TO: Troy Kelts, Galloway & Company
FROM: Stacey Nerger, Senior Planner
DATE: February 22, 2024
SUBJECT: The Exchange Lot 1 – Site Plan
Review Comments 03

EXCHANGE LOT 1 SITE DEVELOPMENT PLAN

Project Number: SP23-080

Description: **The Exchange L1 - Site Plan Amendment Addition and Remodel**

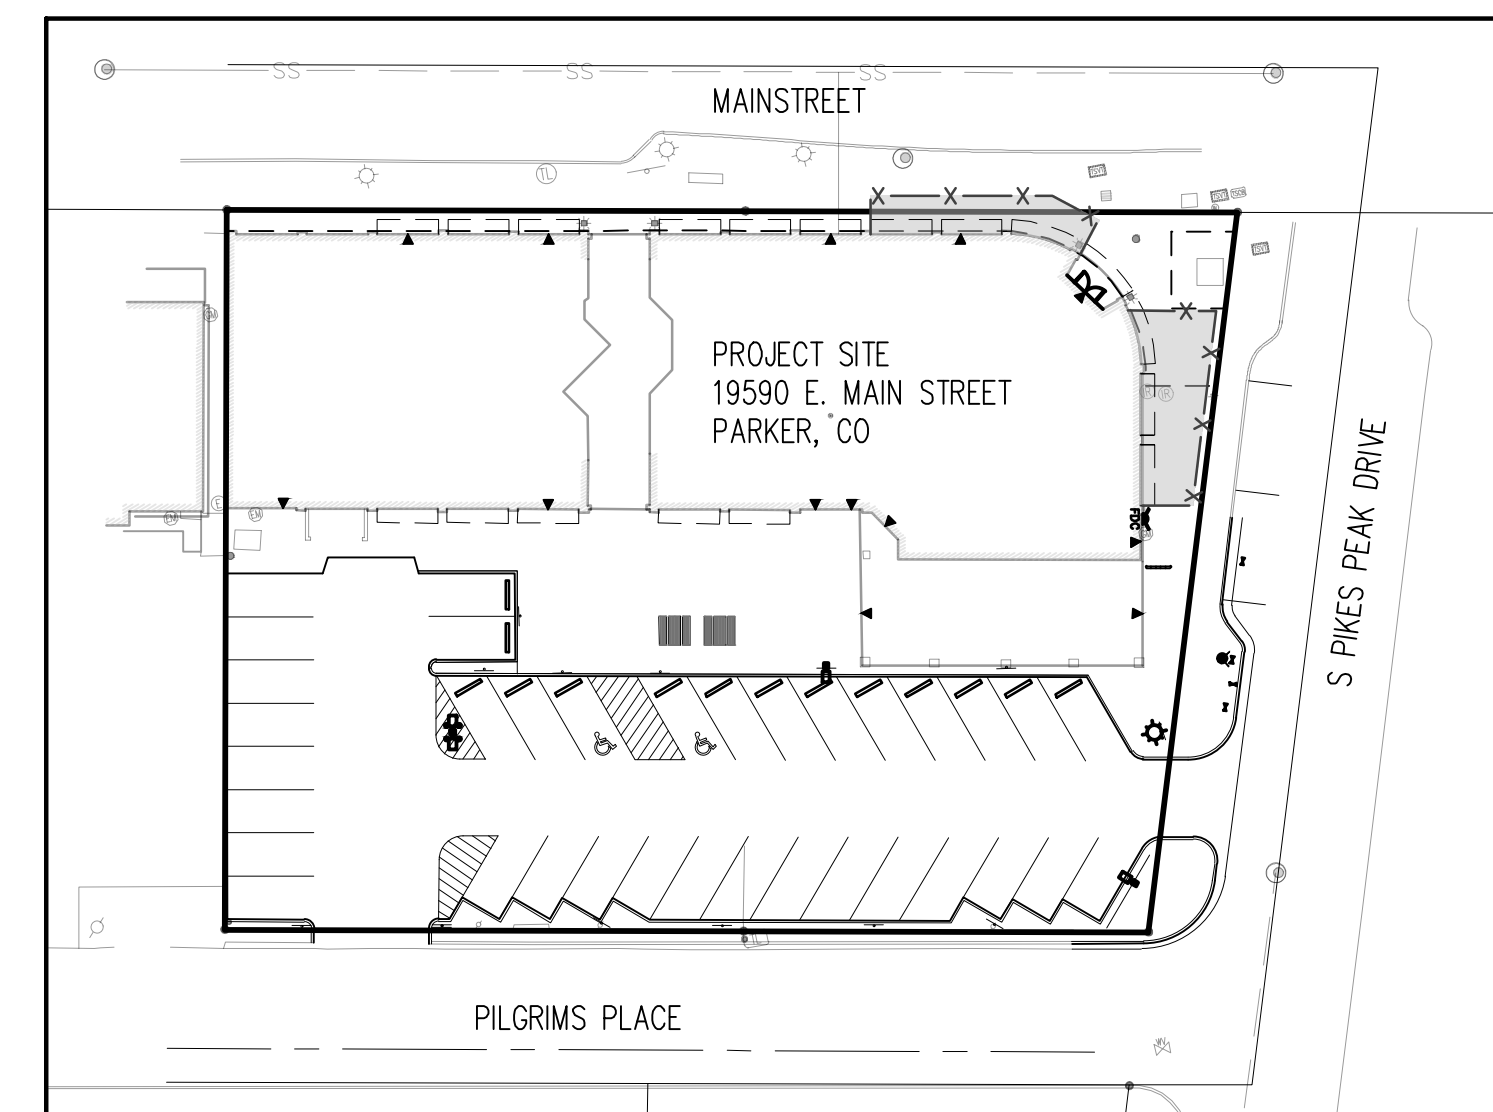
This is labeled hardscape. Does this number reflect parking and access aisles only, or does it include hard surface landscaping as well? If the former, this number is correct to use in your trees and shrubs per 1500 ft calculations. However, if it also includes hard surface landscaping, your calculations are incorrect.

This calculation does not match up with the same measurement on sheet 4, which is 3340. Staff believes this number is correct and sheet 4 is incorrect. Either way, they must match.

EXISTING
CONDITIONS PLAN
2
2 OF 19

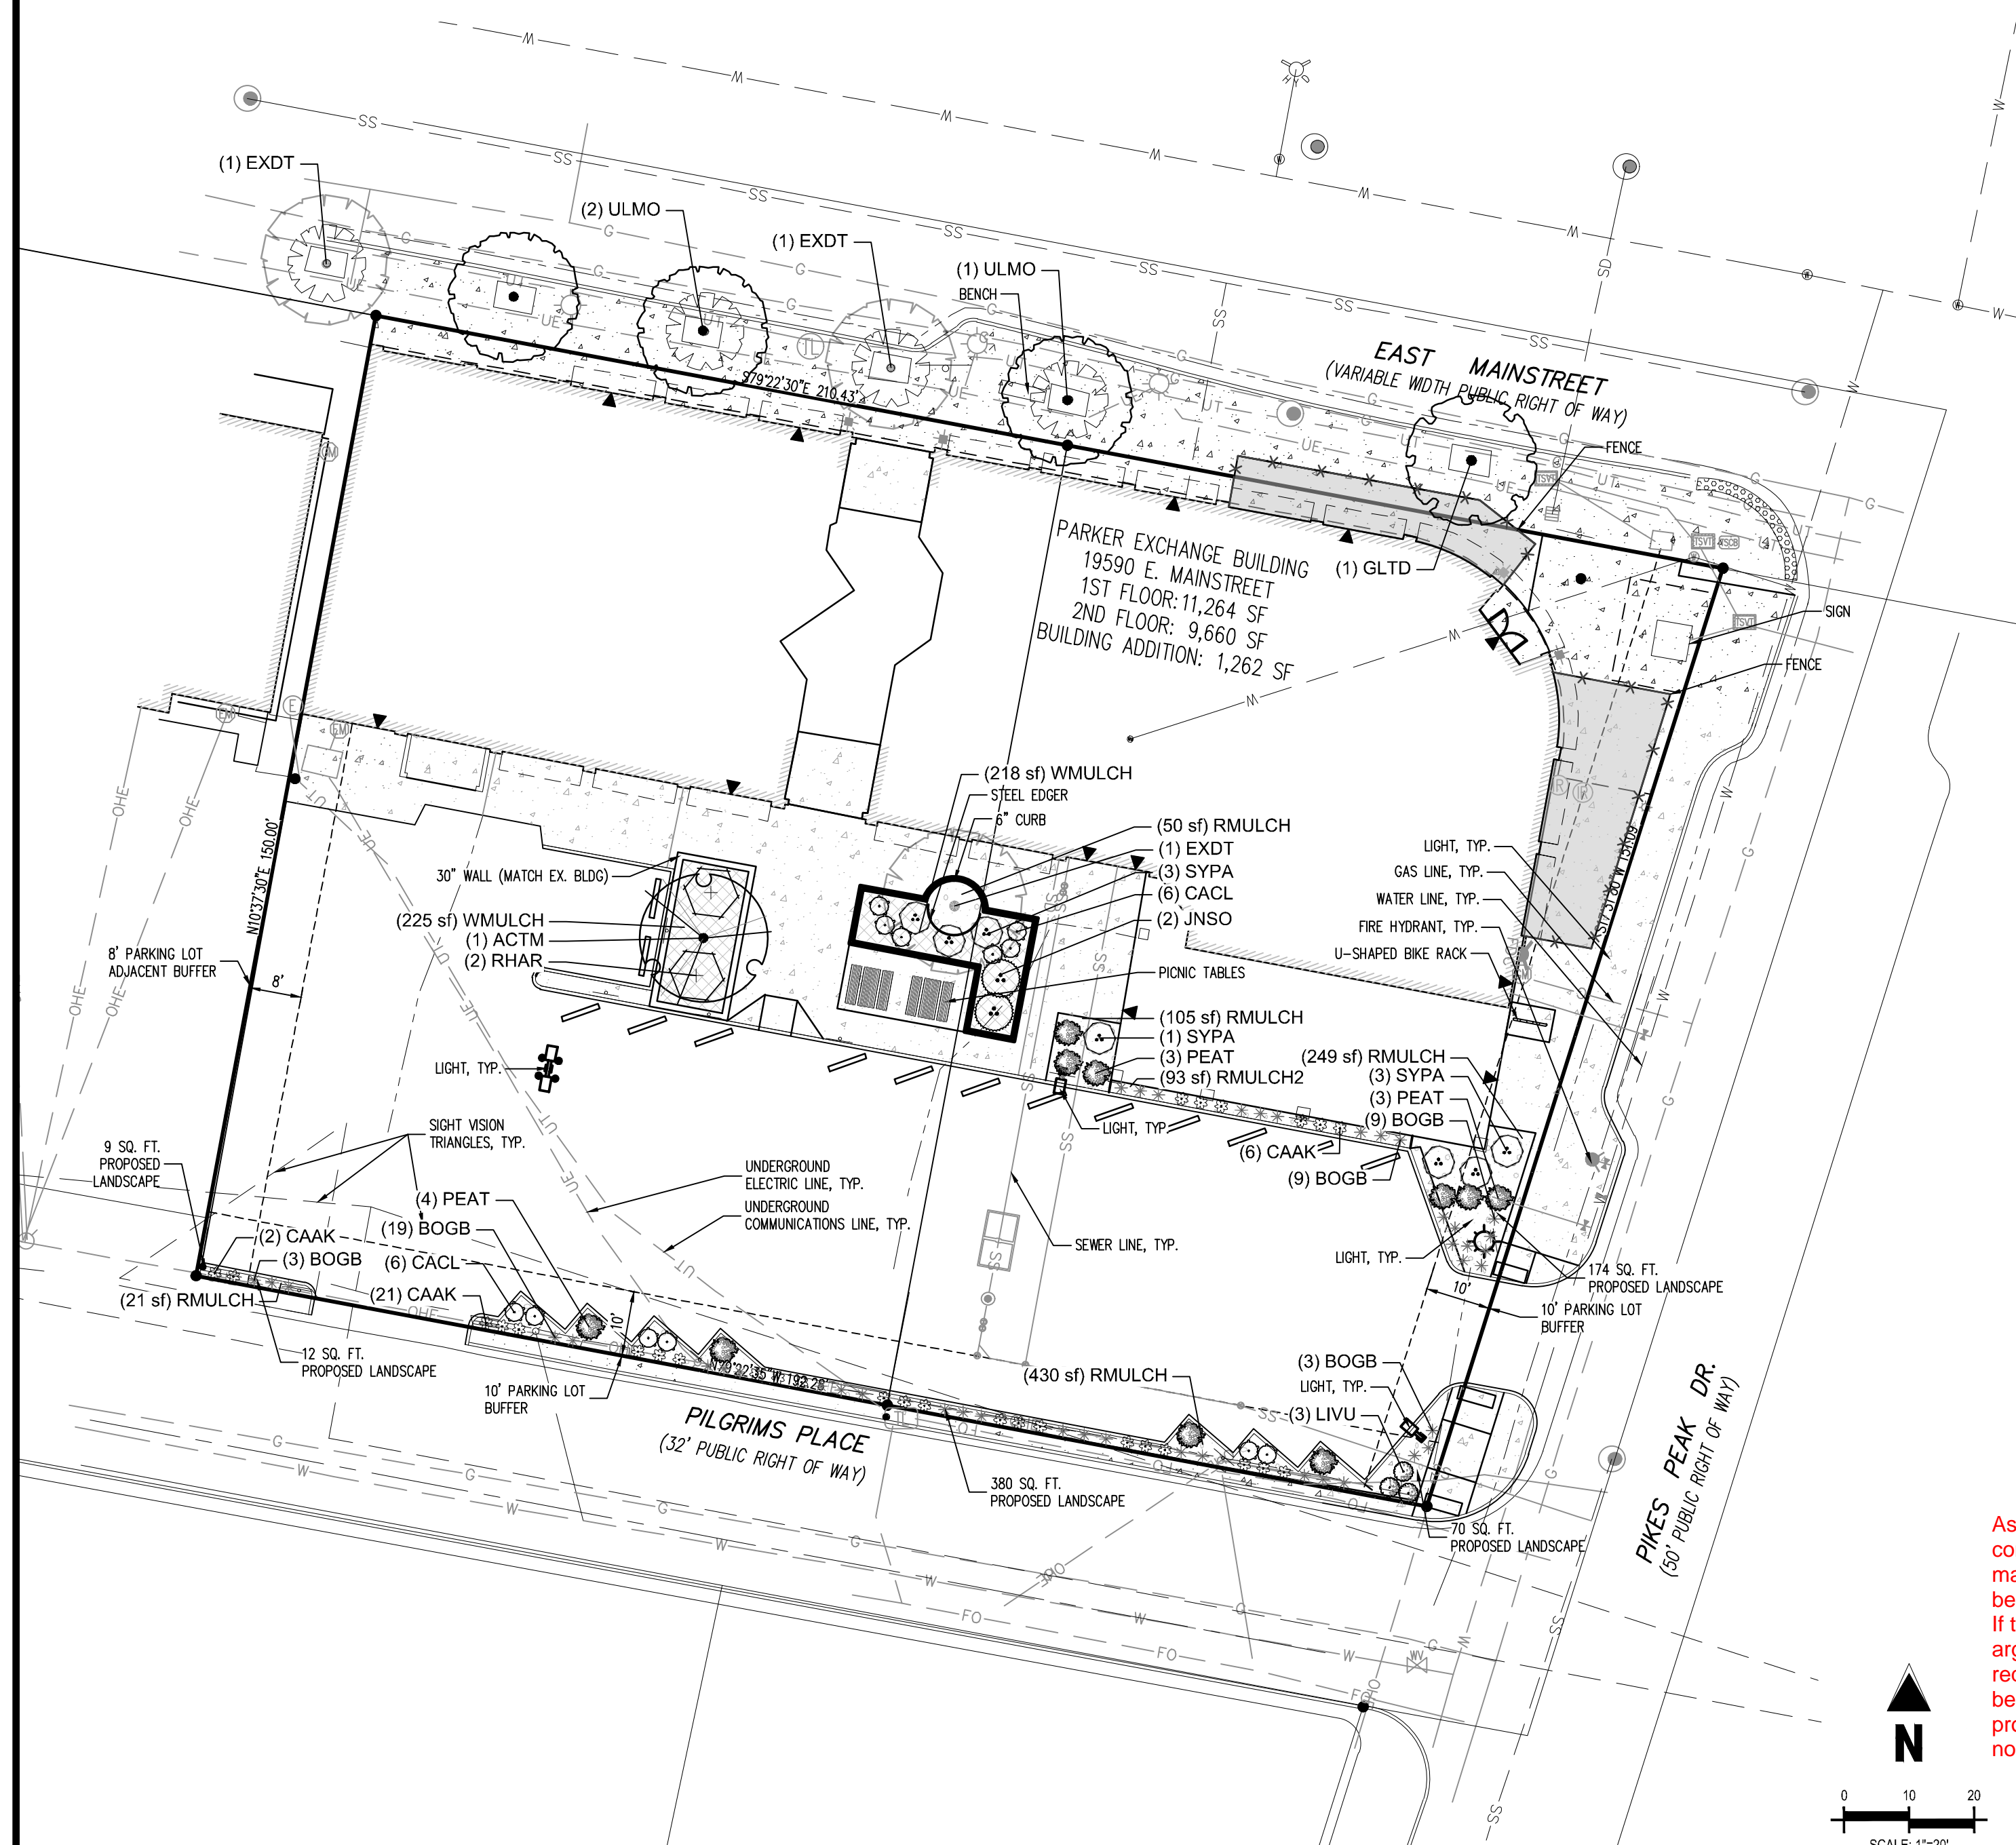
Thank you for adding this to this sheet. Please also label on the next sheet where this will be relocated to.

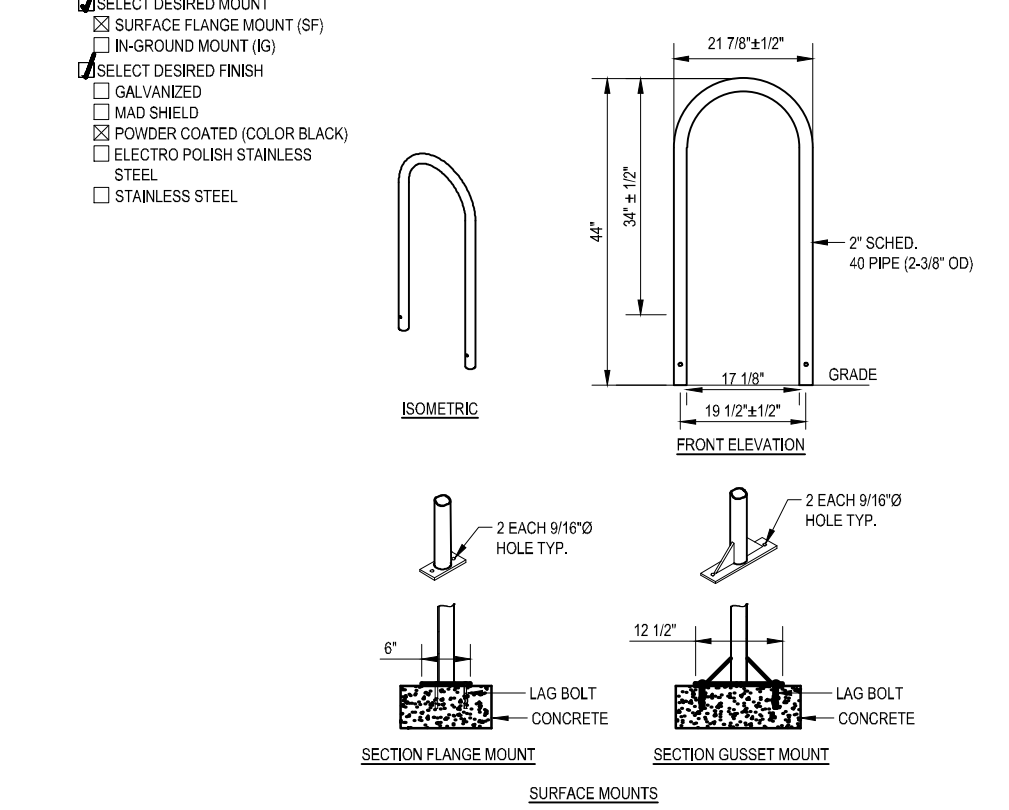
As noted in previous comments the maximum distance between trees is 35'. If there is an argument for why this requirement cannot be met, please provide a detailed note explaining why.

Staff recognizes the note at the bottom of the table, but the note is not clear. Please expand to explain why this requirement cannot be met (Utilities, existing hardscape, ect.)

For the parking lot perimeter, please add an additional column that outlines the additional shrubs and grasses proposed.

Please improve the clarity of this note to provide the reason the requirement cannot be met. May require two notes, one for streetscape and one for adjacent Parking lots

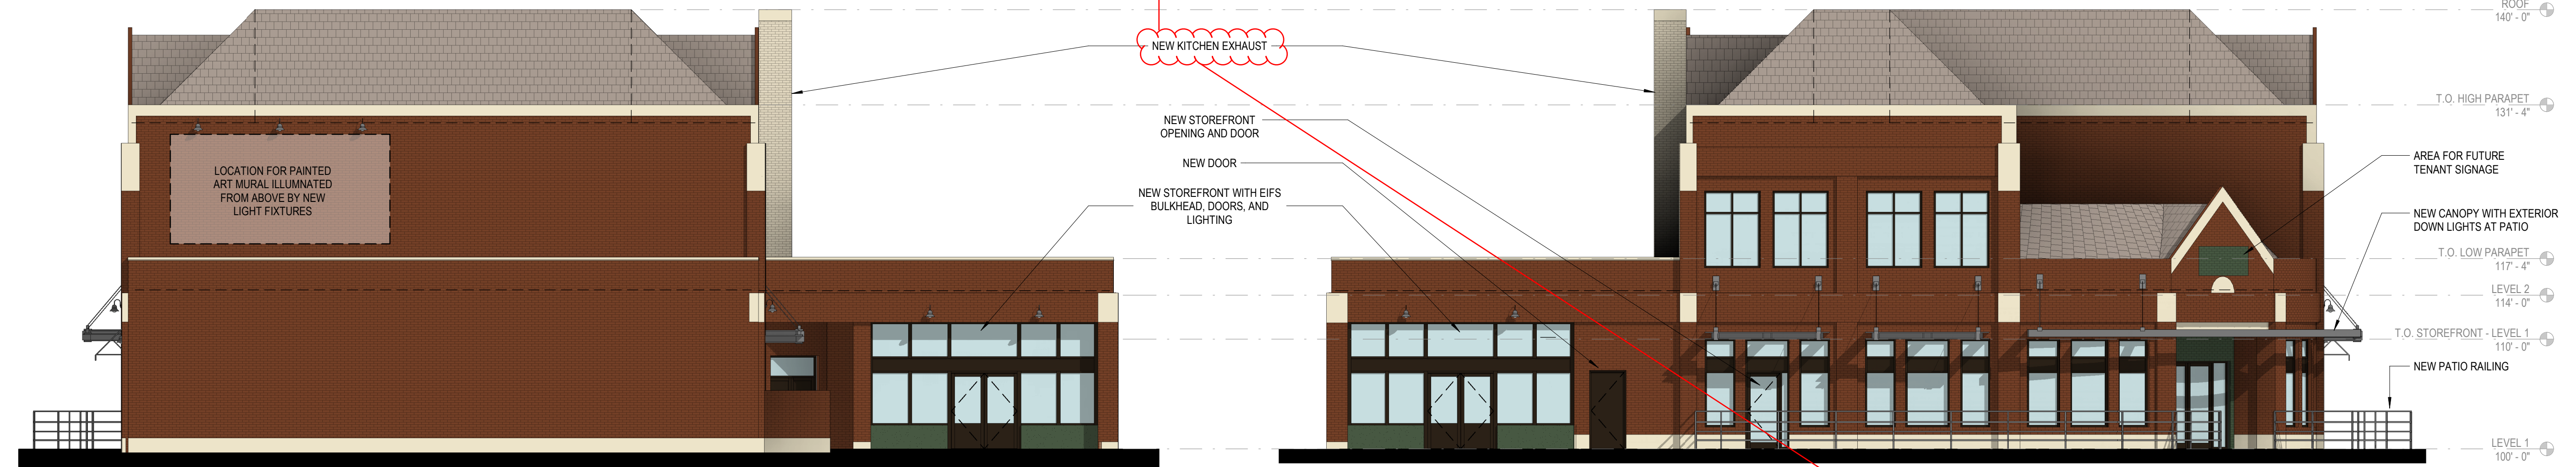
I believe this may be removed. Has this been determined yet? If not, proceeding with this in the plans is ok.
